STATE OF NORTH CAROLINA
DEPARTMENT OF TRANSPORTATION

Subject: Request for Modification to Section 404 Individual Permit and Section 401 Water Quality Certification for the I-40/I-77 interchange improvements including I-40 from west of SR 2003 (Radio Road) to SR 2158 (Old Mocksville Road) and I-77 from south of SR 2321 (East Broad Street) to south of SR 2171 (Jane Sowers Road) in Iredell County. Division 12, TIP No. I-3819B. Debit \$570.00 from WBS 34192.3.2.

Permit Impact Site Modifications (shown in revised permit drawings):

SITE #2

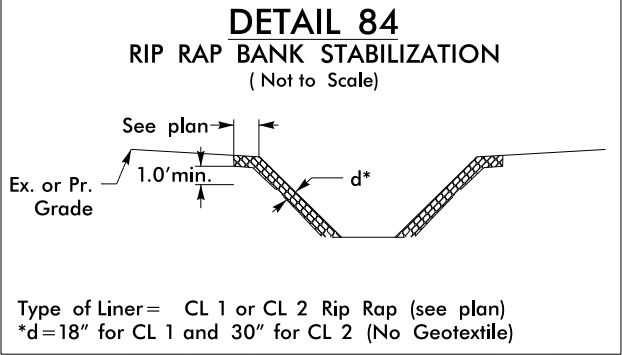
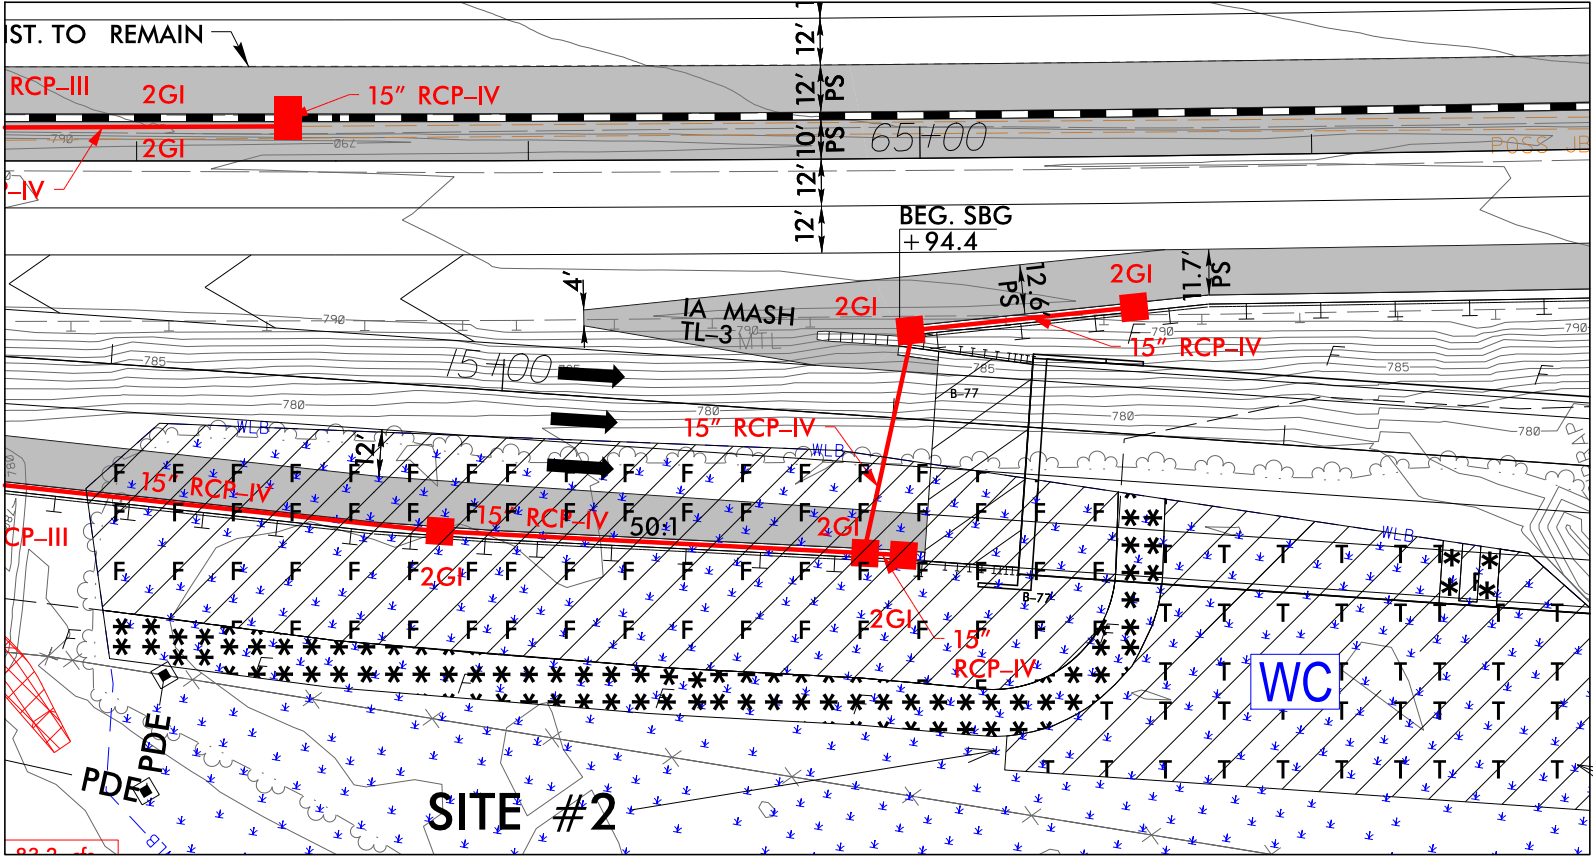
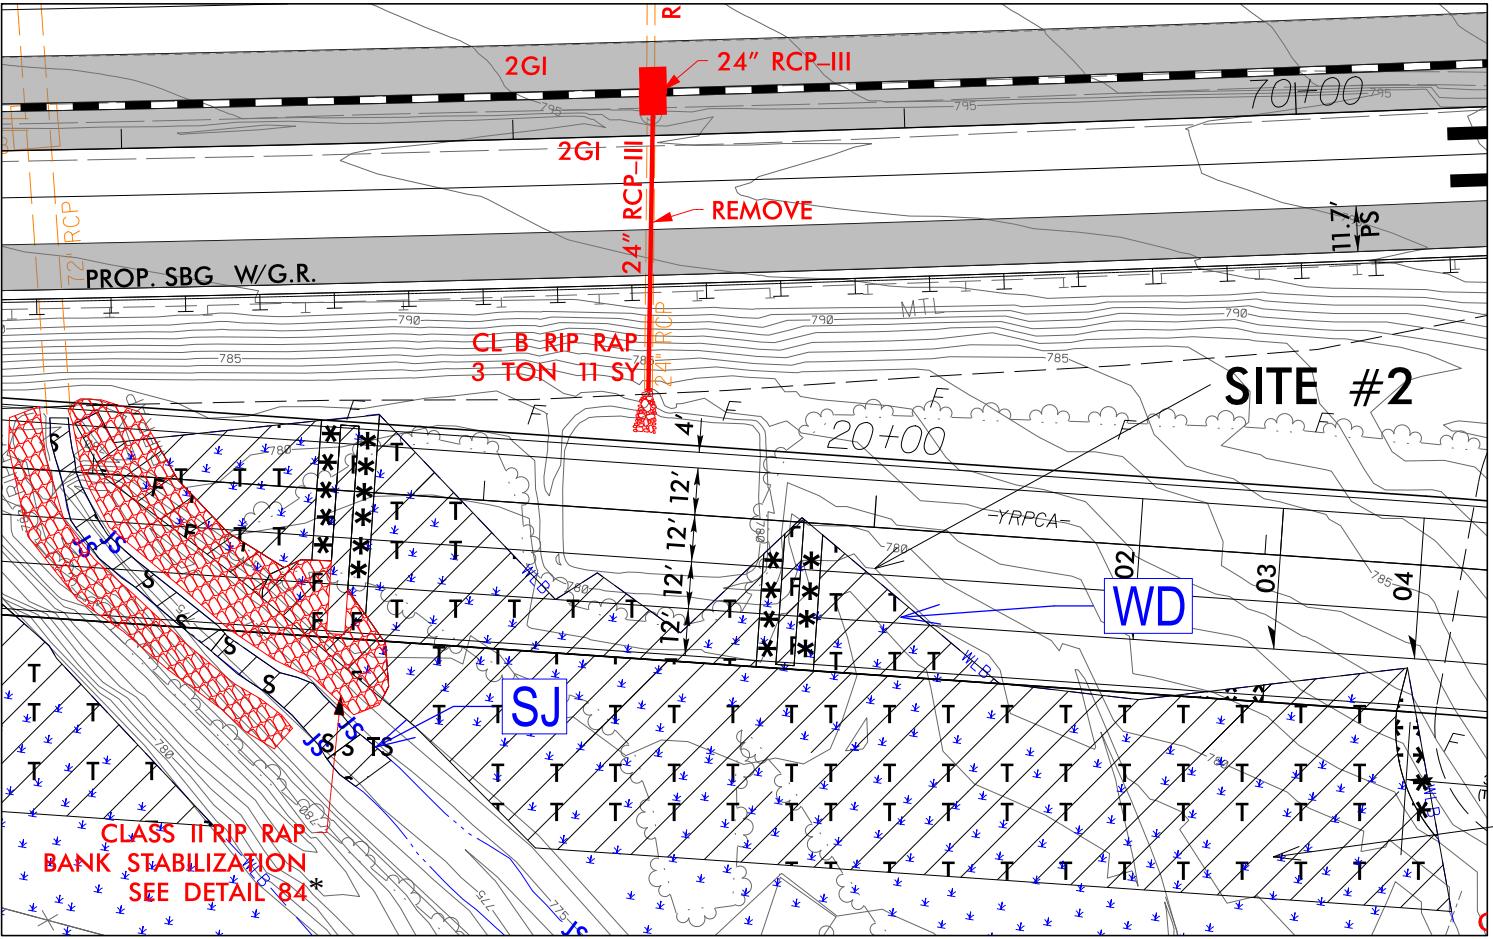
Site 2 (Permit Drawing Sheet 2) – This site has been updated to include riprap bank stabilization along stream SJ under the footprint of the constructed three-lane ramp bridge in this location. Because the bridge is low, the area underneath may not receive adequate sunlight to revegetate; therefore, at the request of Donna Hood with the NCDWR, Class II riprap was installed along the stream banks. Permanent stream bank stabilization impacts increased from 42 linear feet to 115 linear feet, which is 73 linear feet of additional impacts. Temporary stream impacts decreased from 20 linear feet to 10 linear feet, which is 10 linear feet less of impacts.

A section of the bank stabilization riprap was installed within wetland WD in order to reduce the potential for future erosion issues, resulting in minor additional permanent wetland impacts. The extent of the riprap was reviewed in the field and agreed to by NCDOT, Lane Construction, and NCDWR. This area (0.014 acre) was previously permitted as temporary wetland fill impacts and has been revised to permanent wetland fill impacts. Temporary wetland fill impacts decreased from 0.62 acre to 0.61 acre and permanent wetland fill impacts increased from 0.02 acre to 0.04 acre.

*NOTE: RIPRAP WAS INSTALLED
IN THE FIELD THROUGH COORDINATION
WITH NCDWR. NO RIPRAP WAS PLACED
IN STREAM BED.

SITE# 7 & 7A
INSET

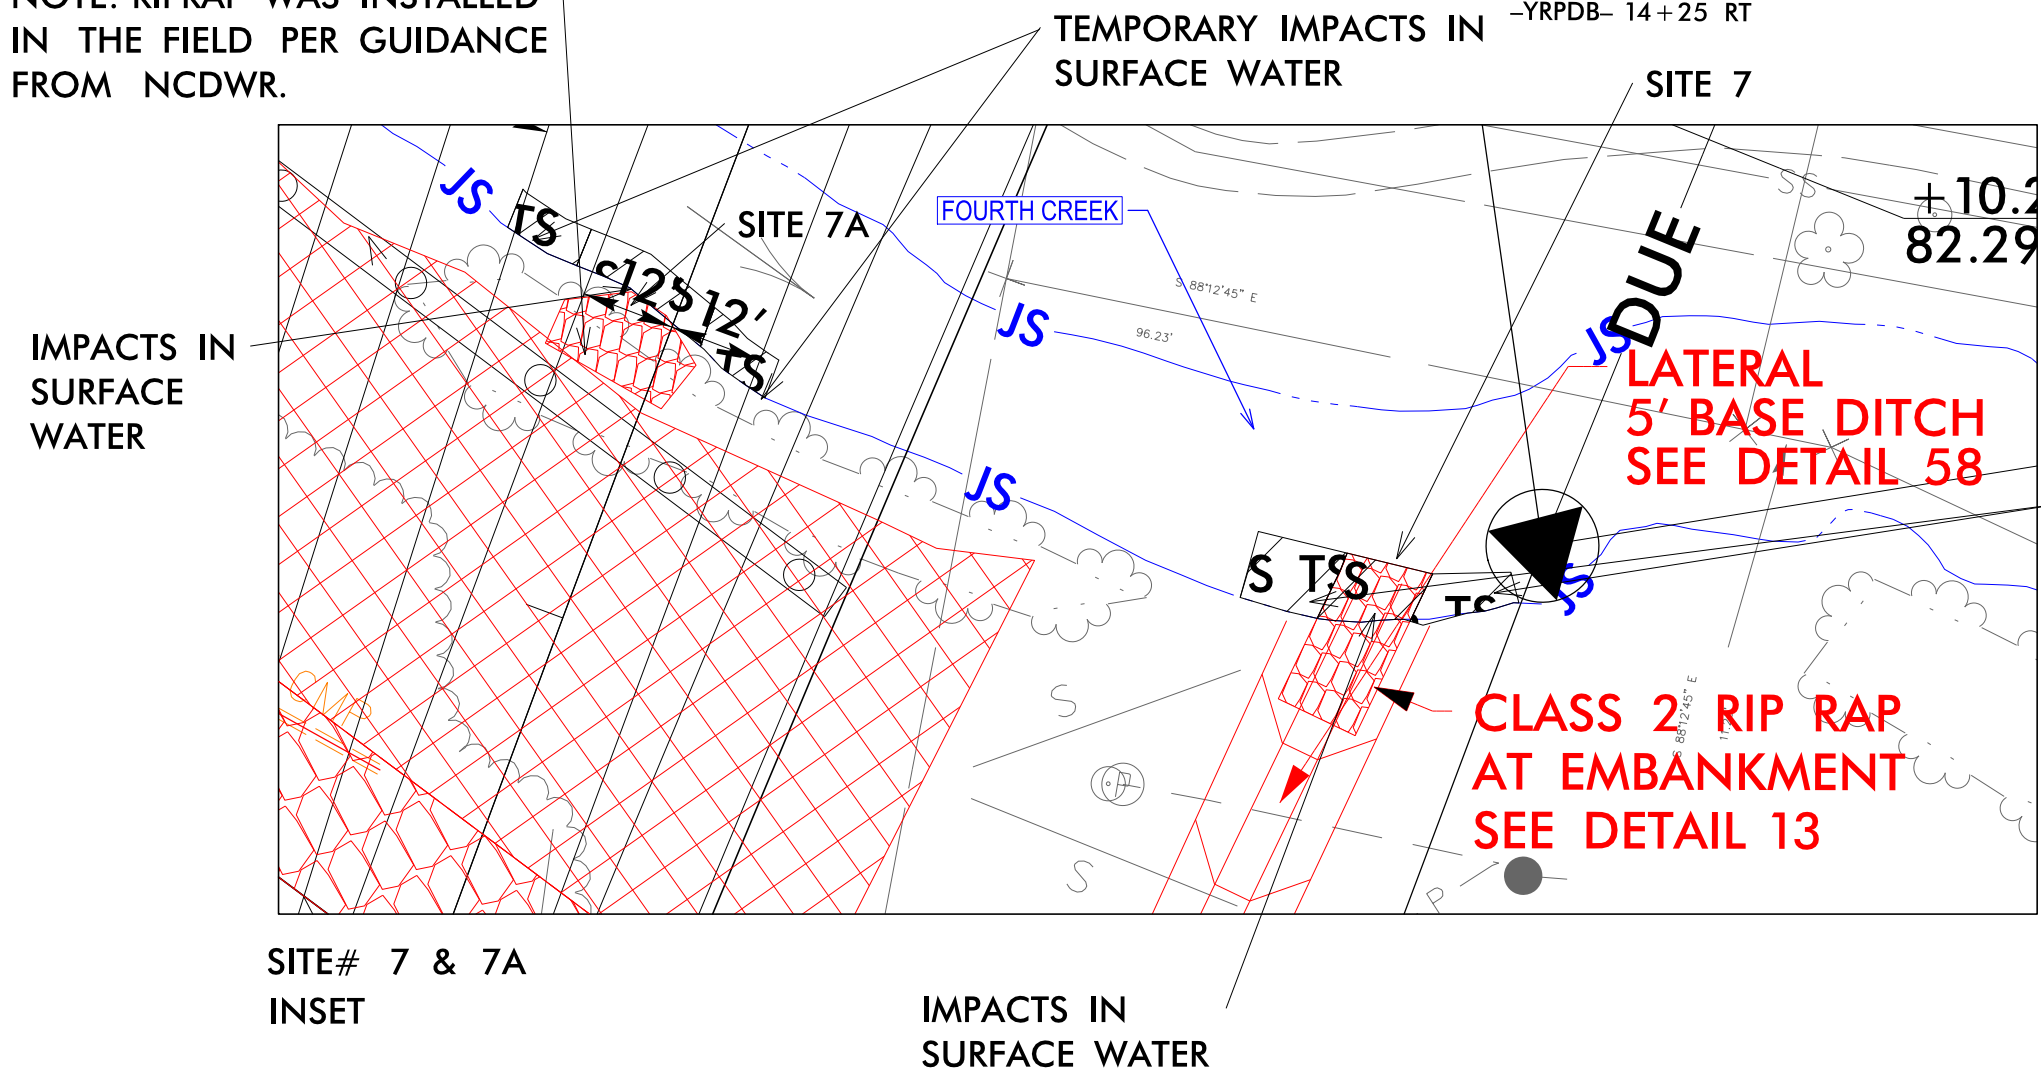
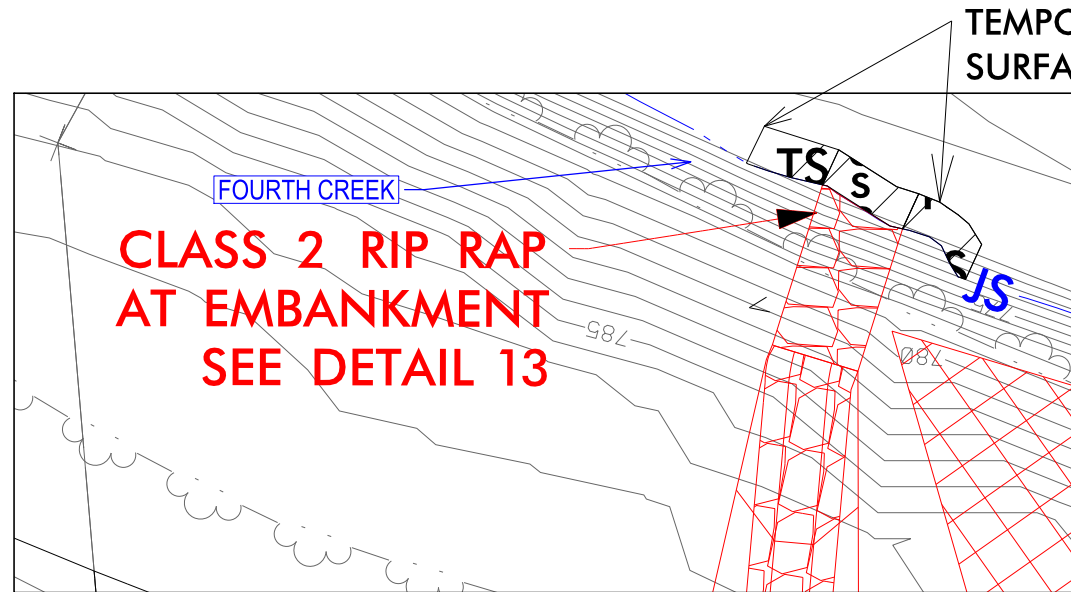
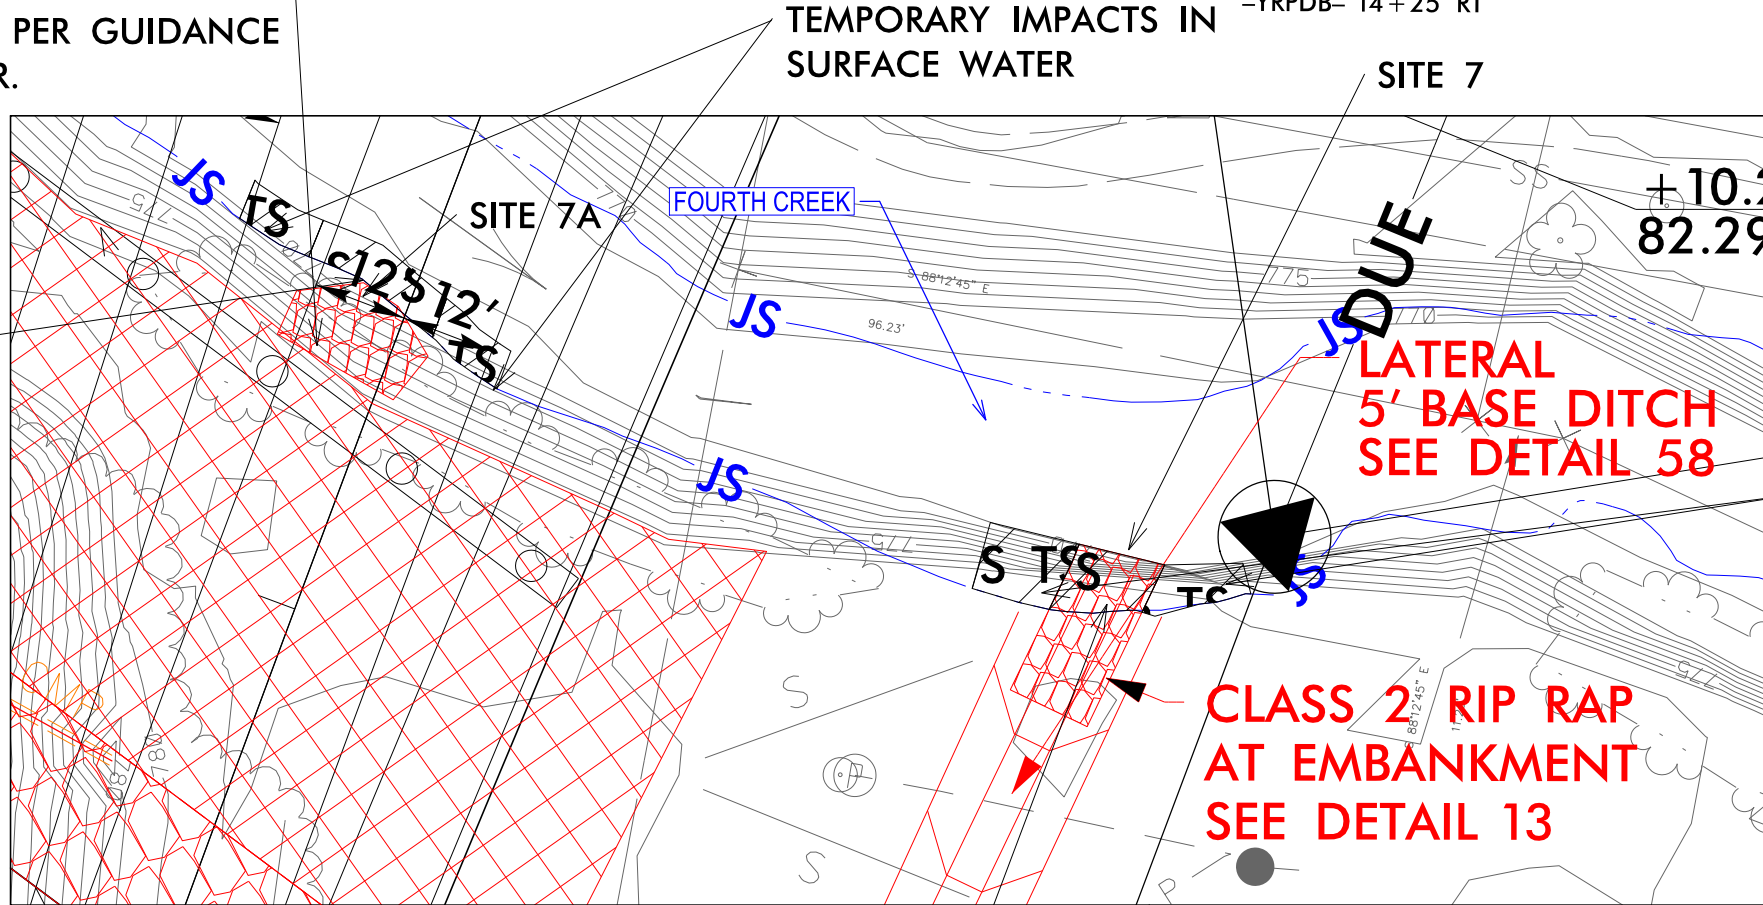
Site 7A (Permit Drawing Sheet 46) – This area was reviewed in the field by NCDWR, NCDOT, and Lane Construction. Upon review, a section of stream bank erosion along Fourth Creek near the new bridge bent was noted. This area is prone to flooding and the bank has experienced erosion during past flooding events. At the request of Donna Hood, Class II riprap was installed along the stream bank to provide stabilization in this location. Impacts resulting from this addition of riprap included 19 linear feet of permanent stream bank stabilization impacts and 21 linear feet of temporary stream impacts.

NOTE: RIPRAP WAS INSTALLED
IN THE FIELD PER GUIDANCE
FROM NCDWR.
